### **ROADWAY DESIGN BULLETIN 11-03**

### **DCE MEMORANDUM 02-11**

**SUBJECT: OSHA RULE (29 CFR Part 1926) CRANES AND DERRICKS IN CONSTRUCTION**

Example 1

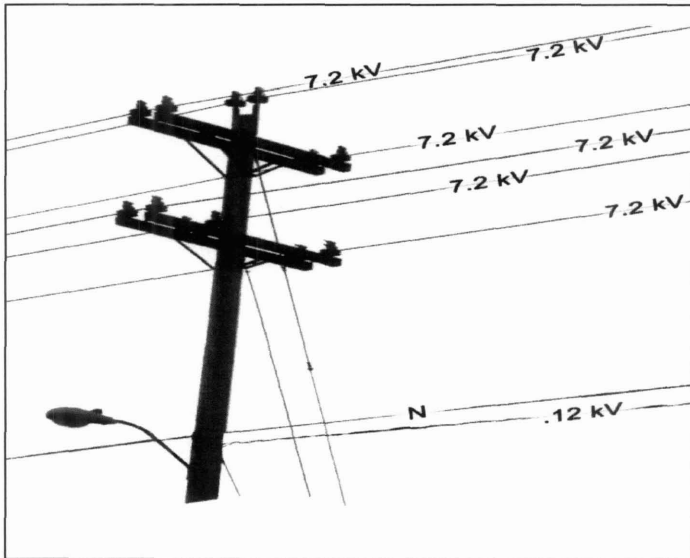
For all projects with a letting date after July 1, 2011, all overhead electrical facilities shall be labeled with the line voltage. Utility owners will be required to furnish the line voltages at the coordination phase. Multiple lines with different voltages may be found on a common pole line. For labeling purposes only one line should be shown even if there are multiple lines with different voltages. For poles with multiple lines and multiple voltages which do not exceed the 50kV threshold (see Example 1), the line should be shown in the plans as -----OE (< 50kV)-----.

Example 2

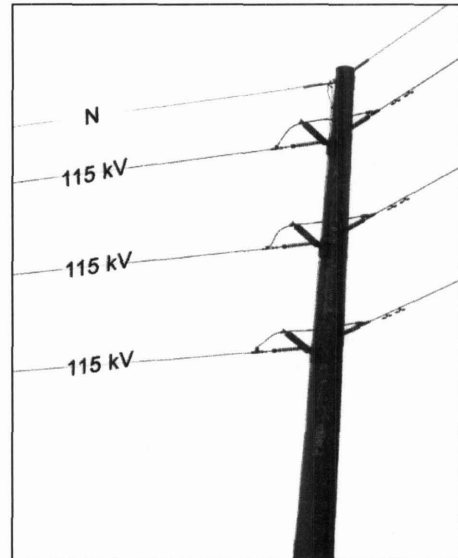
For poles with multiple lines and multiple voltages which exceed the 50kV threshold (see Example 2), the line with the greatest vertical clearance will be labeled first, separated by a slash mark, and followed by the next voltage as you move down the pole. If multiple voltages exist at

the same height, the highest voltage should be labeled. In Example 2, the line should be shown in the plans as -----OE (115kV/115kV/115kV)----- or -----OE (All lines 115kV)-----.
